**Subject: Expedited Site Assessment Work Plan Addendum
Shore Acres Gas, 403 E 12th Street, Oakland, California
Fuel Case RO0002931 and Global ID #T0600174667**

Insight Environmental, Engineering, and Construction, Inc. (Insight) is pleased to submit one copy of the work plan addendum for your review. This work plan addendum was prepared in response to the Alameda County Environmental Services letter dated 10 August 2007. The letter requested that Insight address four technical comments regarding our work plan dated 25 May 2007. Insight will address each technical comment separately.

<p>Figure 4 PROPOSED BOREHOLE LOCATIONS Shore Acre Gas 403 E 12th Street Oakland, California</p>		
DRAWN: J. Hurst	DATE: 9/5/07	
FILE: Projects\5-70004\Proposed borehole locations.dwg		5-70004

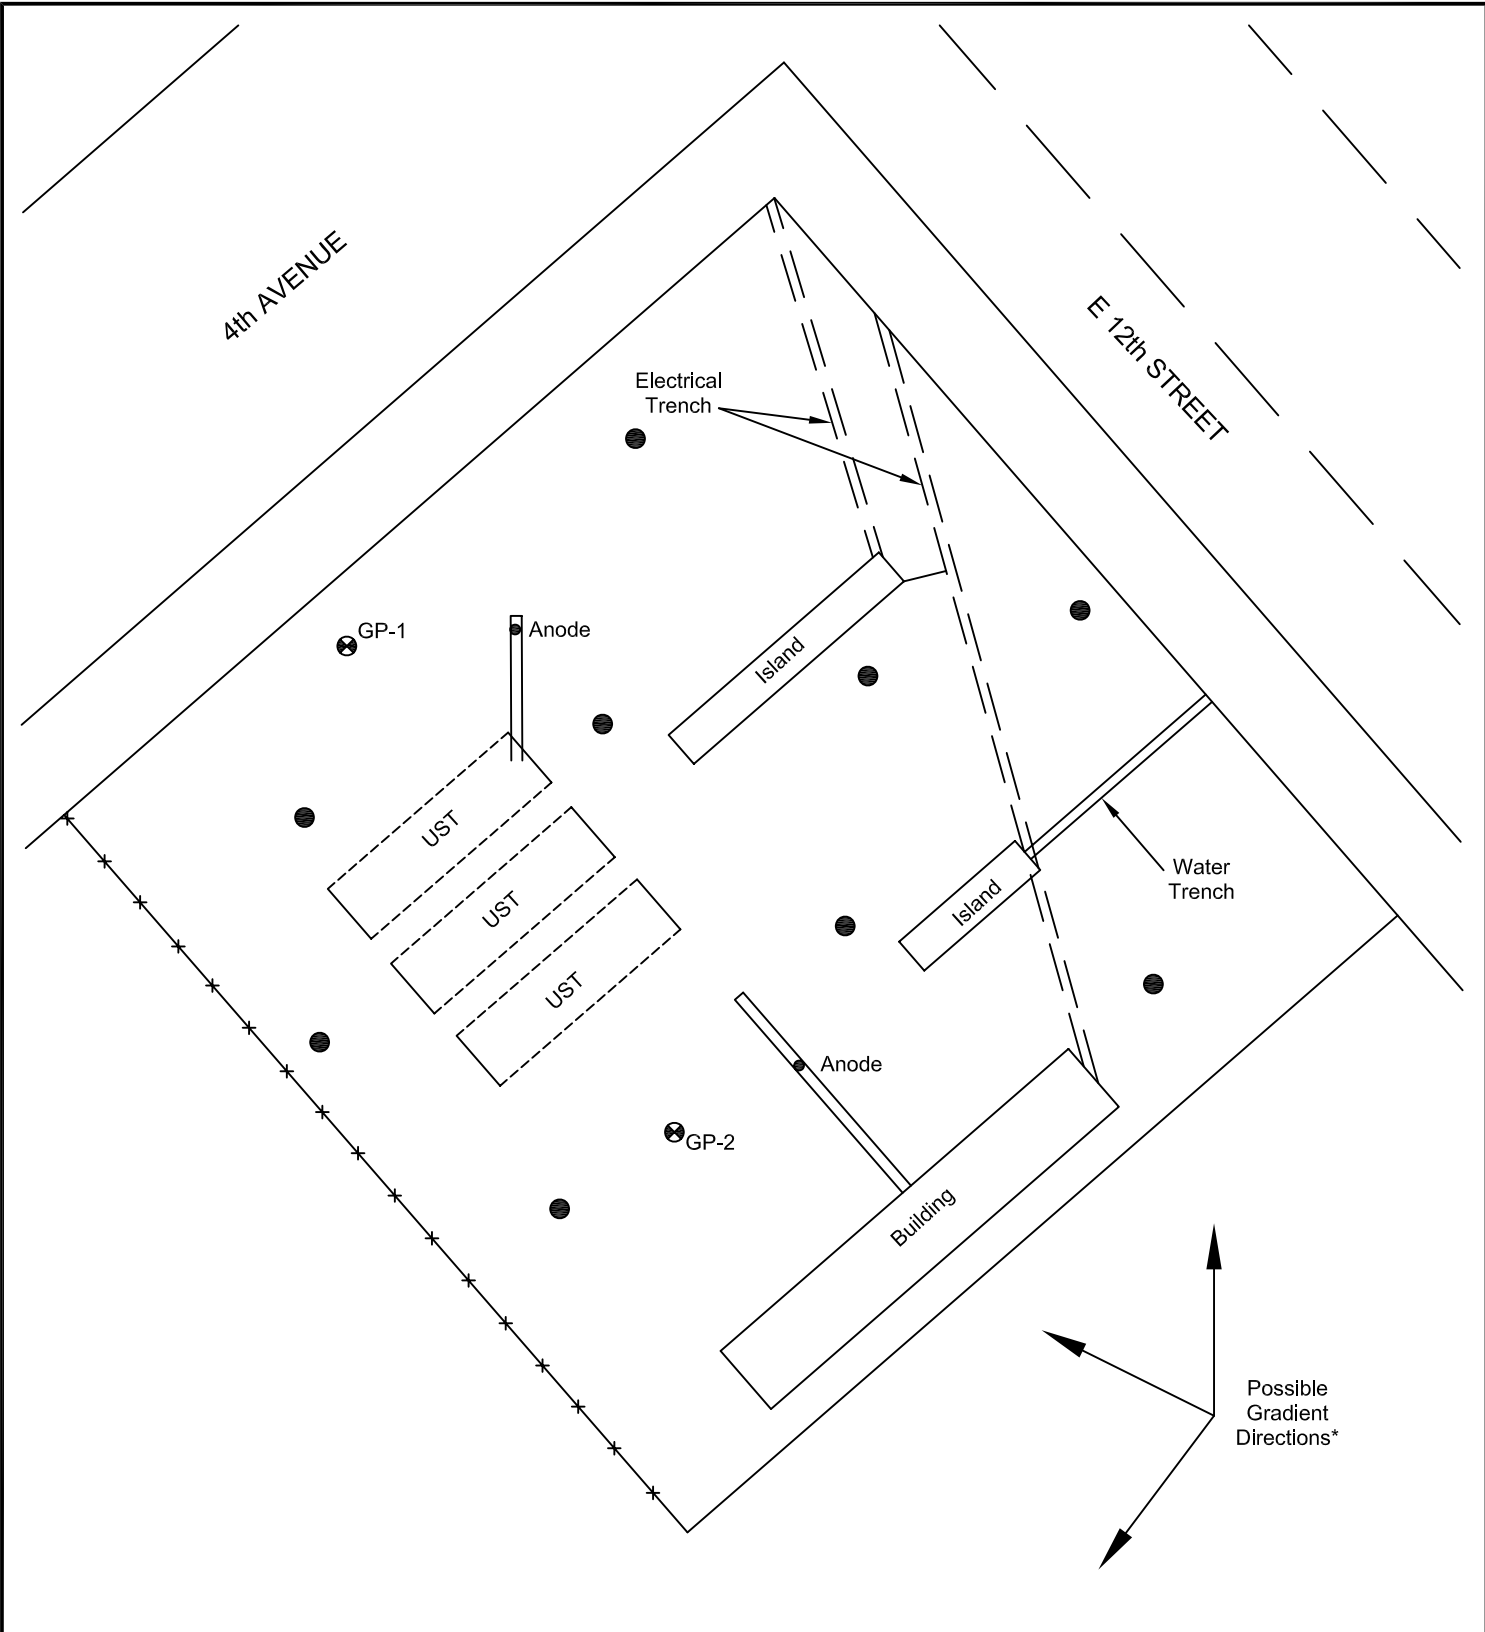
Comment 1. Estimated Site Gradient-Based upon your consultant's record search, no wells were located within a ¼ mile radius of the site. Therefore, no current sites exist with monitoring wells to estimate groundwater depth or gradient. Insight states from GeoTracker, the inferred gradient is easterly, however, we believe that it is not likely in that direction. The gradient at a closed site at 45 E. 14th (International Boulevard) was reported as northwest and depth to water was from 8-13 feet below ground surface (bgs). If we look at the nearest water bodies from the site, Lake Merritt Channel, Lake Merritt and the Oakland Inner Harbor, it appears that the gradient should be northwest, west or southwest, but not easterly as inferred. In addition, although the initial Geofon borings did not encounter groundwater at a depth of 20 feet bgs, this appears to be deeper than would be expected.

Comment 2A. The borings should be placed and sampled to determine the lateral and vertical extent of contamination. Assuming a generally westerly gradient (possibly northwest or southwest), the borings should be placed in a transect down-gradient and perpendicular to the source(s). The potential sources at this site are the USTs and the pump islands. Attached please find a site plan with boring locations noted in this type of array.

Response 1. Insight concurs with this comment and the attached figure has been revised. Insight based the previous easterly flow direction on a GeoTracker site approximately ¼ mile to the east.

Response 2A. Concur. The DPT borings have been relocated as shown on the attached figure based on the data provided by the County of Alameda.
